**105 S Glenwood conditional permit**

Mary (Khaki) Westerfield  
[101 South Glenwood Avenue](#)  
[Columbia, MO 65203-2732](#)Ross Halligan, Planner  
Community Development Department  
RE: [105 South Glenwood Avenue](#)-Conditional Use Permit (Case #19-2026)

Ross Halligan, Planner  
Community Development Department  
Re:105 South Glenwood Avenue - Conditional Use Permit (Case #19-2026)

Re: 105 South Glenwood Avenue - Conditional Use Permit (Case #19-2026)

Fig. 1. Photo of 105 S. Glenwood showing crumbling masonry in front, taken on 11/30/25.

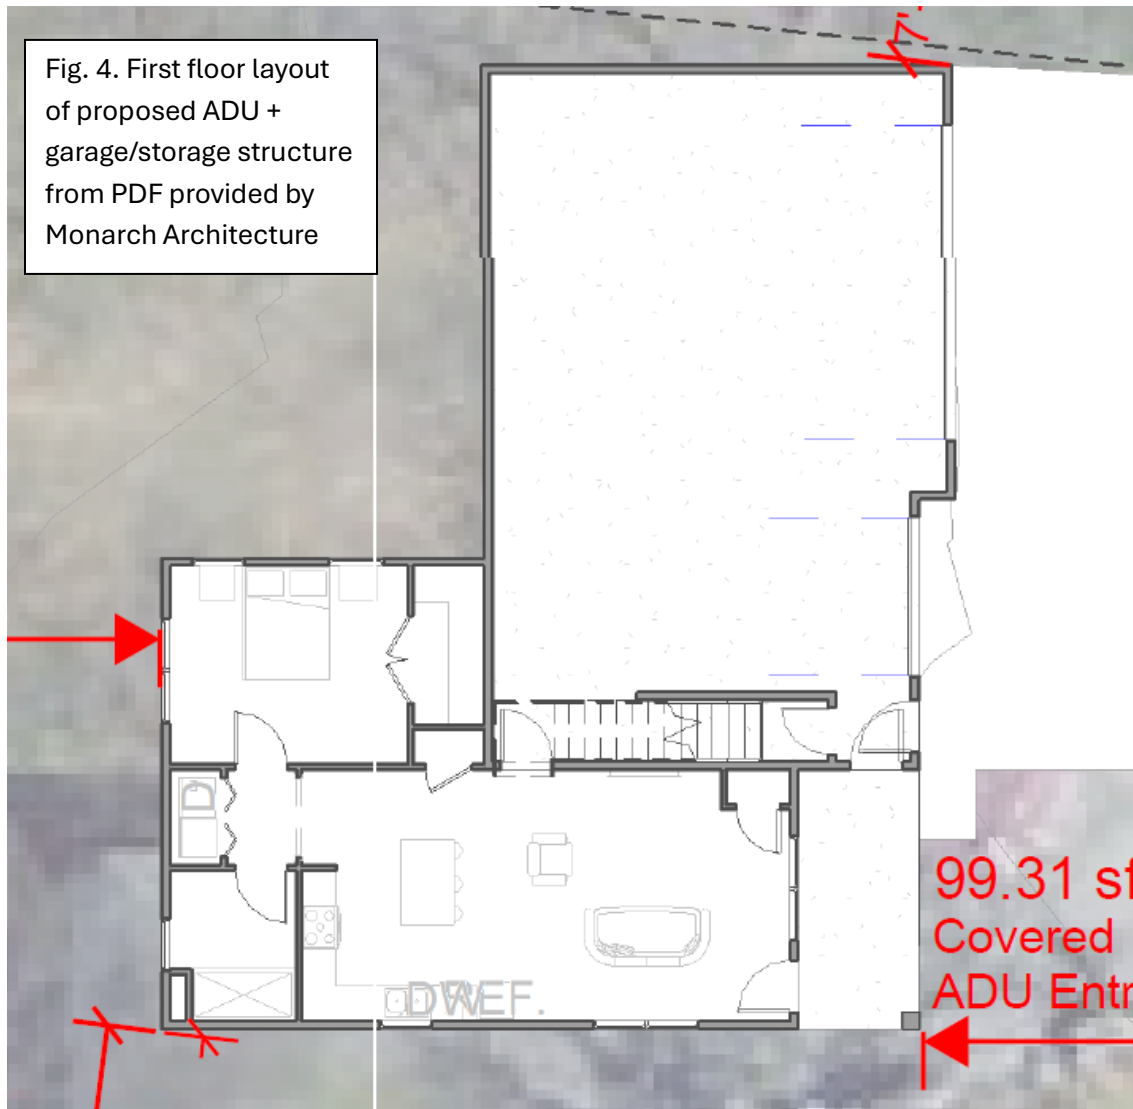
2. The proposed size of the aggregate structure is wholly dependent upon the simultaneous enlargement of the primary structure to 1839.9 ft<sup>2</sup>. We are hopeful that the historic, primary house will be remodeled to meet occupancy and safety codes, as it has been vacant for ~5 years, suffered from several prior years of neglect, and is currently in serious disrepair, including crumbling masonry and holes in the exterior visible from the outside (Figs 1, 2, & 3). For these reasons, we are concerned that despite good intentions, the primary structure may fail to be successfully expanded as proposed in the request. Therefore, we disagree with the simultaneous consideration of the contingent ADU request. The 100+ year old primary structure has not been maintained for a very long time, and successful expansion and renovation of the primary residence should be completed prior to considering new construction. The proposed aggregate structure size (ADU + garage) exceeds the maximum allowed based on current conditions. **Following the prolonged non-occupancy of the primary residence, the ADU request is premature and should not be based on a future condition that has yet to be achieved.**
